IC Corporation

OSV-124
SAFETY RECALL 05505

Recall Campaign # 05505 & SUBJECT (Engine Cover Retention Cable)

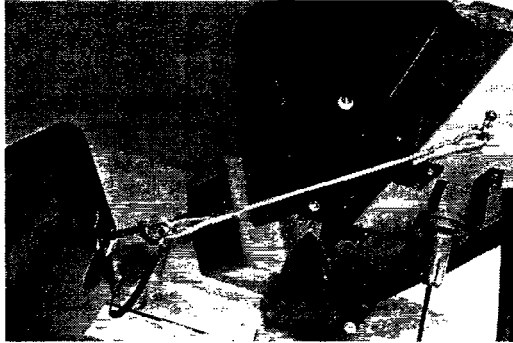
4. For units with optional windshield defogger code 048PKD, the first latch bracket can be installed on the flange of the bulk head in order to clear the grille.
